## 14\_01 1ft. 6in. curb and gutter

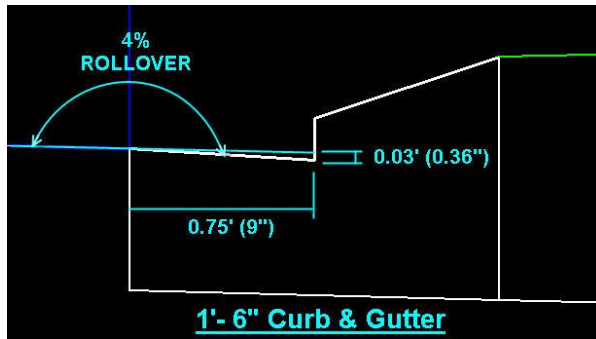
When a 1'-6" curb and gutter element is drawn in the xsc files produced by Roadway, it doesn't match the standard as shown in the Standard Drawings, 846.01, sheet 1 of 3. In the Standard, the gutter pan is parallel to the bottom of the curb and gutter. But in the xsc files we get from Roadway, the gutter pan will be sloped and not parallel to the bottom.

Which is it supposed to be?

The problem arises if the hydraulic engineer is determining "spread" of stormwater on the pavement and including the "drop" in the gutter when the "drop" isn't actually there. Also, the determination for the "top of grate" elevation for drop inlets won't be correct.

What is discussed here is the 4% rollover at the EOT to the gutter pan. The difference at the gutter's flow point elevation can be as significant as 0.03' (0.36").

Discussing the drawing standards for 1'-6" curb and gutter over with Plans and Standards Management, it is agreed that our Criteria will not apply any rollovers for 1'-6" curb and gutters. The gutter slope as well as the base slope will both be the same as the roadway pavement superelevation rate.
